<b>Drax BECCS Project Planning Examination 2022-2023</b>	<b>Deadline 9 (D9), July 6th 2023 Submission</b>
--	--

<b>Author Details</b>	
Name	<b>Dr Andrew Boswell</b>
Position	<b>Scientist and Consultant</b>
Drax BECCS Project registration	<b>20032289</b>
Organisation	<b>Climate Emergency Policy and Planning (CEPP)</b>
Examination Principle Issues	<b>Climate Change</b>

## **DEADLINE D9 SUBMISSION SUMMARY**

**Figure CEPP.Drax.Fig-1 :**  
*The functional inter-dependence of upstream and downstream operations*

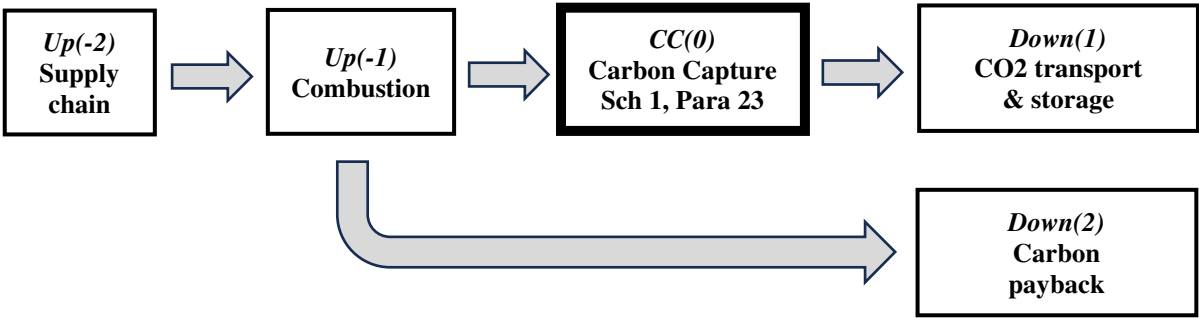
31 For the proposed development to operate, then, there is a causal relationship between these different operations and processes. The functional inter-dependence of the different operations is sequential and identified is as follows. The output of Up(-2) is the input to Up(-1). The output of Up(-1) is the input to the development itself which I’ll refer to as “CC(0)”. The output of CC(0) is the input to Down(1). The output of Up(-1) is Down(2). The numbers indicate a time causality ie: -1 happens before 0 etc. At a high-level, causal relationship of the operations is:

32 The Applicant’s problem is that they have conflated operations Up(-2) and Up(-1) with CC to different extents in the EIA Scoping Report. As the distinction between the operations is blurred (conflated), the Applicant’s Scoping Report on GHGs (Chapter 15 of [APP-115]) does not properly distinguish between likely significant “direct effects” and “indirect effects” for the purposes of EIA: in fact, for GHGs, it does not even identify direct and indirect effects. The scoping report analysis appears to have been focussed on “PAS 2080” typology assignments, but failed to clearly determine which effects are “direct” and which are “indirect”. The PAS 2080 typology of GHGs types is a helpful tool but it does not substitute for correct EIA assignment, and assessment, between direct and indirect effects under the 2017 Regulations.

33 Critically, CC(0) is the only operation which comprises the development under this planning examination. However, critically, the Applicant uses the word operation in an umbrella sense which conflates the upstream operations with the CC operation itself. As noted, the Applicant’s umbrella use of operation also does not correctly identify the downstream operations, CO2 transport and storage, and the carbon payback process for EIA purposes.

34 However, the operation of the development, CC(0), is functionally inter-dependent with the upstream and downstream operations. The carbon capture operation cannot take place (or functionally exist) without the upstream and downstream operations. The upstream and downstream operations have likely significant environmental effects associated with them. In the proper understanding of the 2017 Regulations, these are

I have clarified above in Figure CEPP.Drax.Fig-1 and the surrounding narrative that the development (CC(0)) is a carbon capture development under Schedule 1, paragraph 23. However, in terms of the 2017 Regulations, the likely significant indirect impacts of the functional inter-dependent upstream and downstream operations are required to be estimated and assessed. It is not relevant if the combustion has already been consented and is in operation: the emissions from the combustion are strongly causally related to the carbon capture. Simply, the carbon capture operation cannot happen without the operation of the combustion. Therefore, for EIA purposes the combustion (Up(-1)) process is an Indirect effect of the CC(0), the development being considered under the 2017 regulations.
